## **Town of Arlington, MA Redevelopment Board**

### **Agenda & Meeting Notice July 22, 2019**

#### **1. Environmental Design Review, 1207-1211 Massachusetts Avenue, Arlington, MA - Docket #3602 Public Hearing**

# SPECIAL PERMIT - SITE PLAN REVIEW

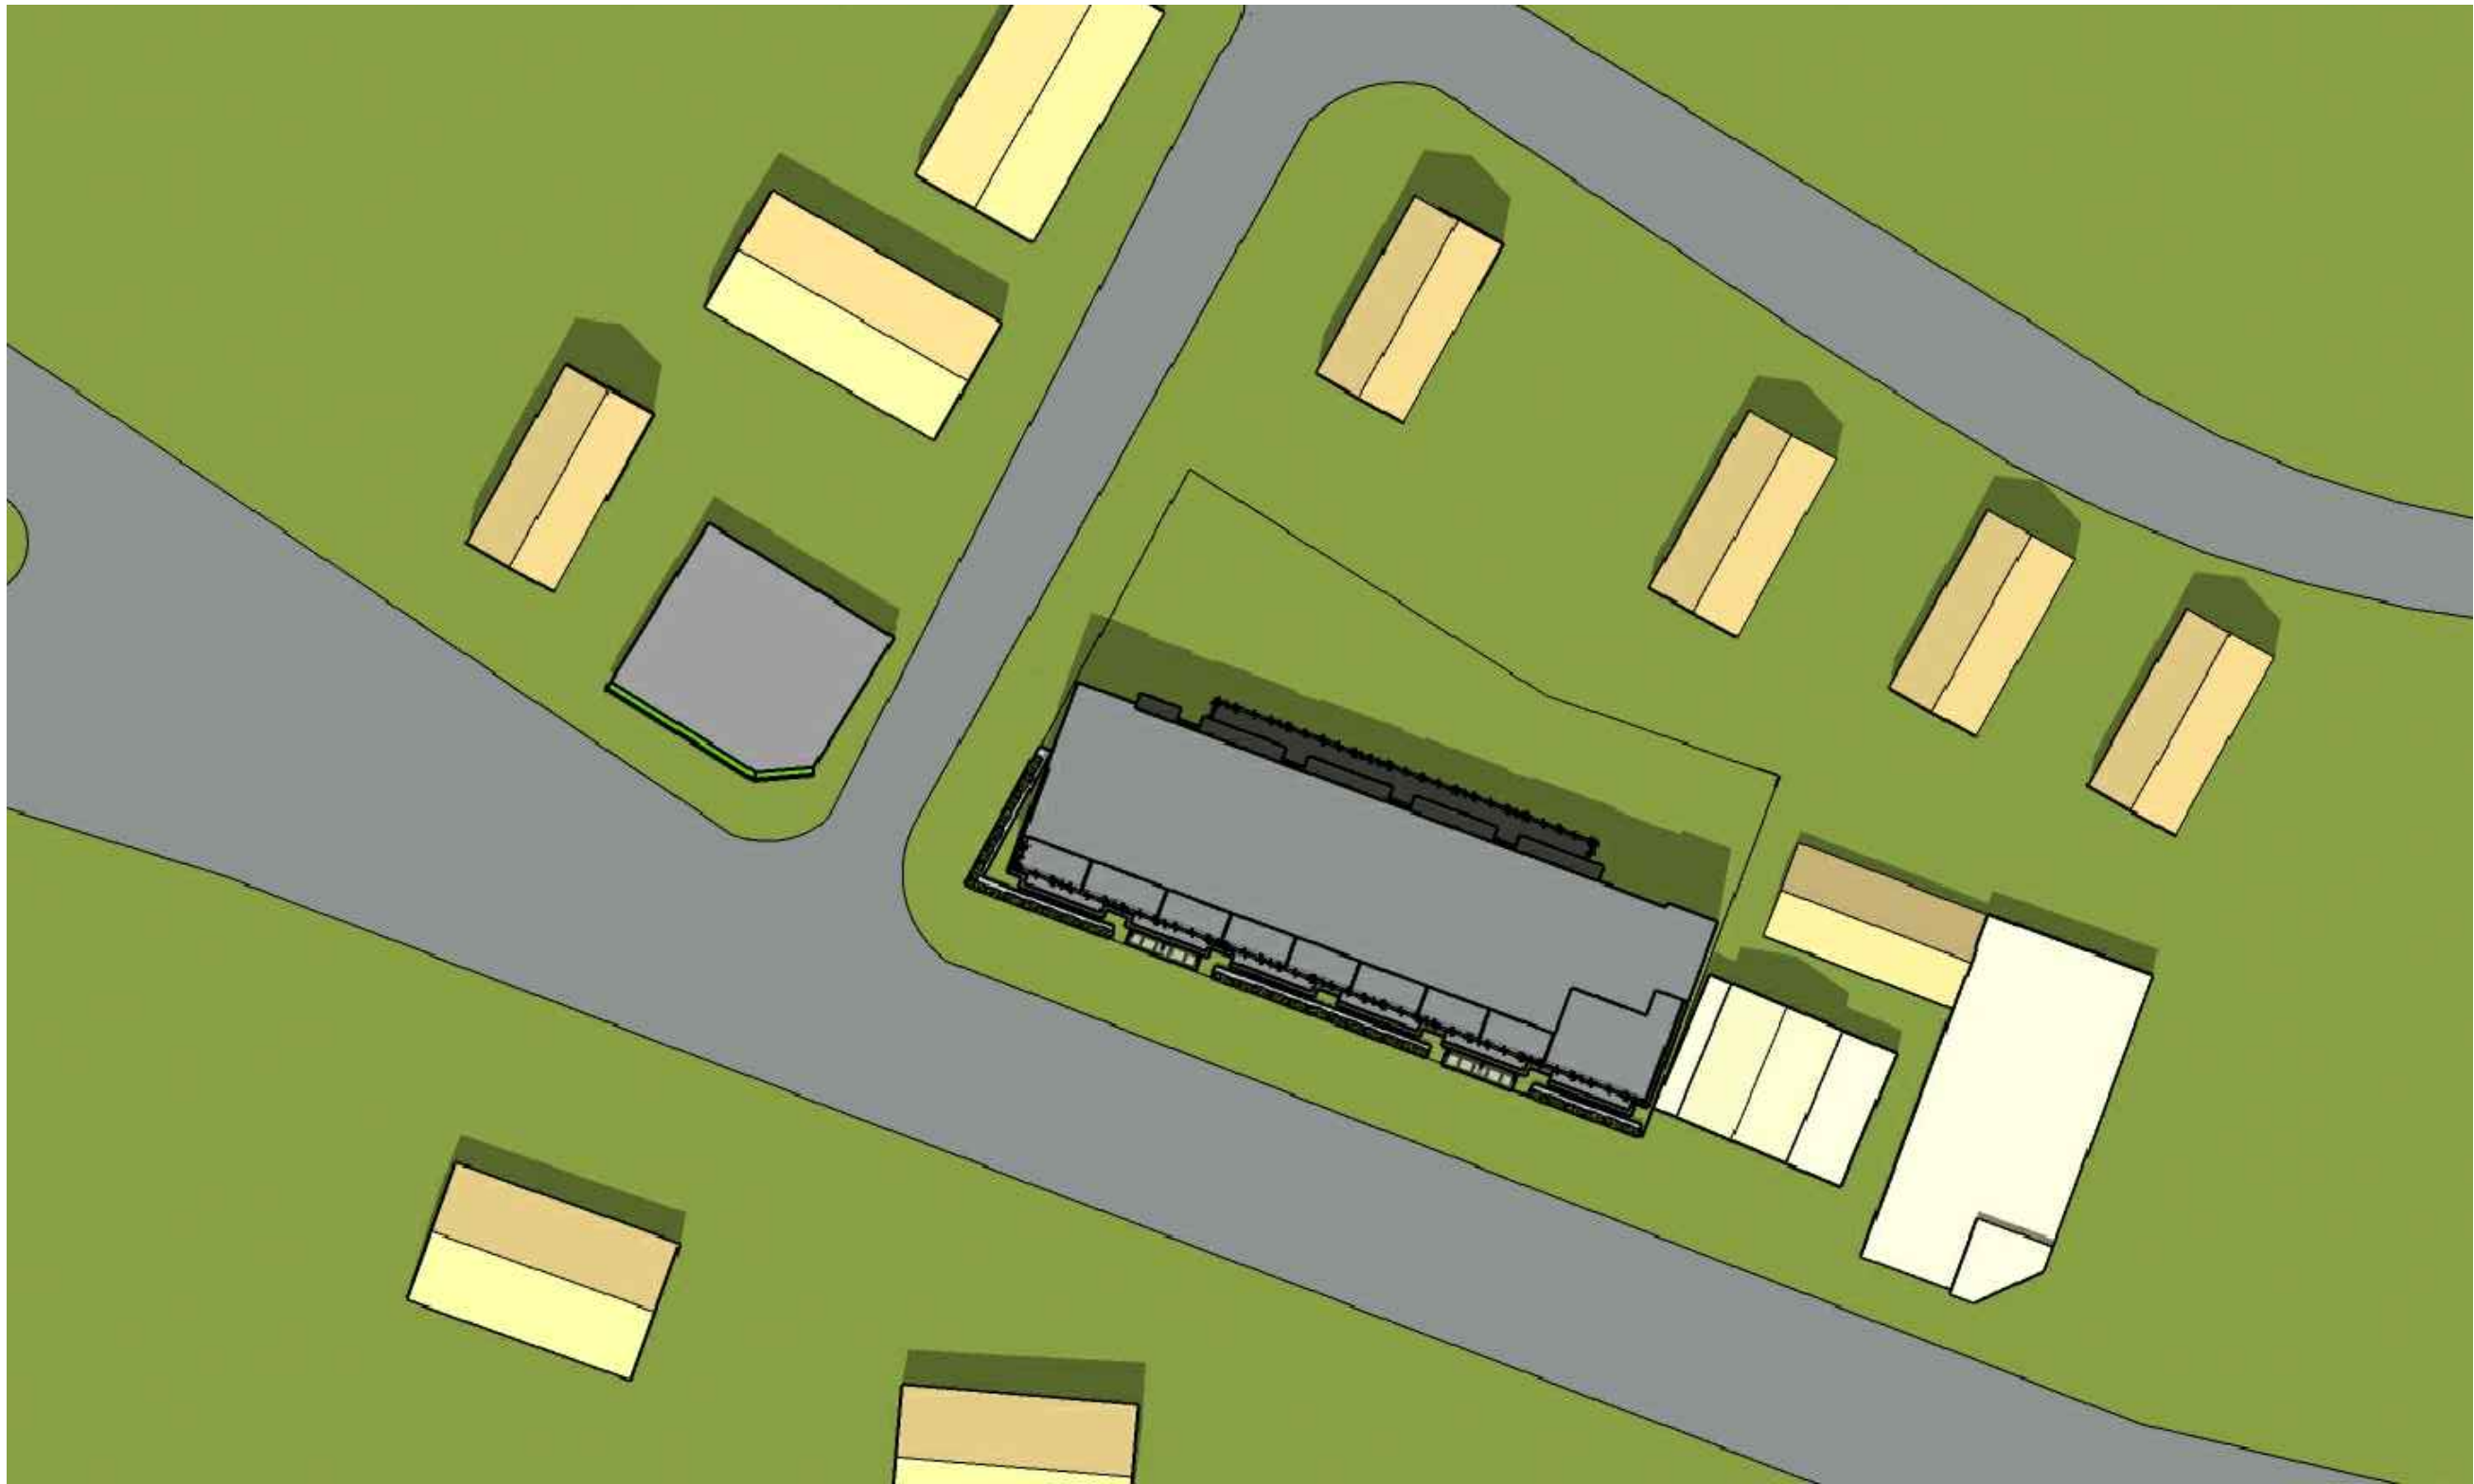
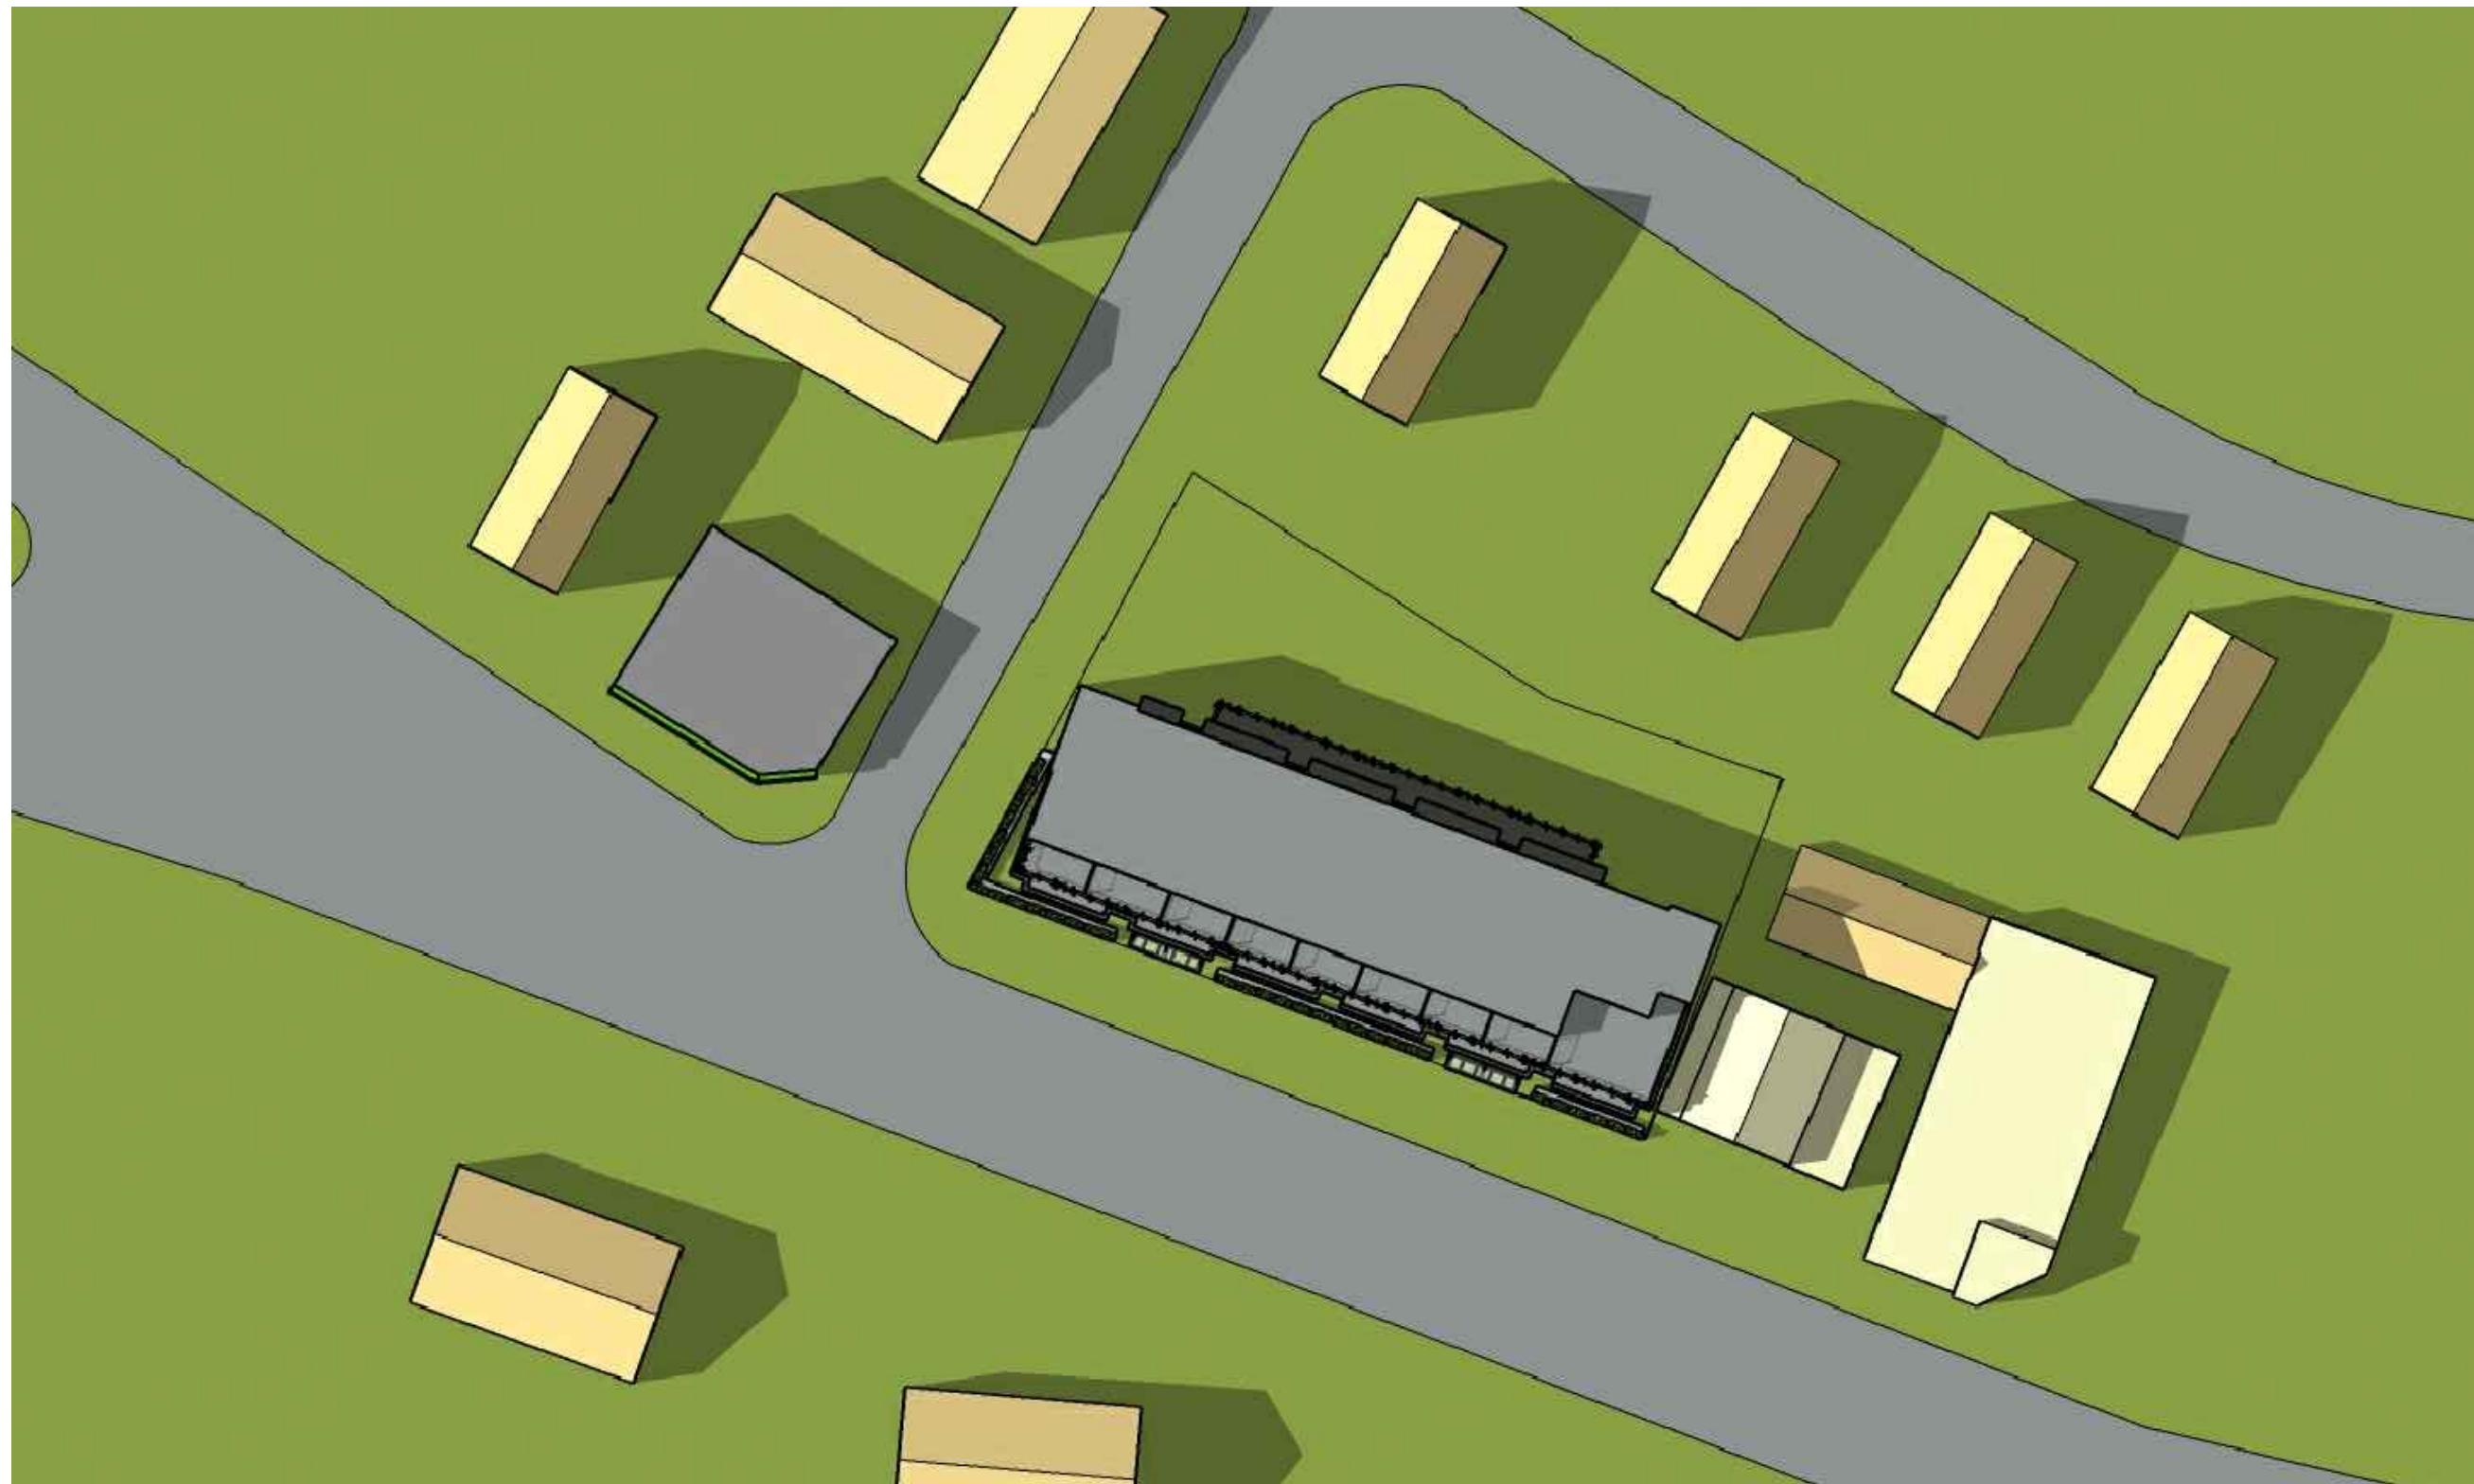
The building does not trigger the height buffer area of Section 5.3.19 because it is proposed at the lower maximum stories and height as identified in the Table of Dimensional and Density Requirements for the Business Districts. However, the application materials also provide a shadow study during each season at the respective Solstice and Equinox.

The proposed changes do not appear to significantly affect the immediate microclimate, however, the height of the new building may create shadows on adjacent residences, and the proximity of Mill Brook should raise questions about additional stormwater inputs and flooding impacts.
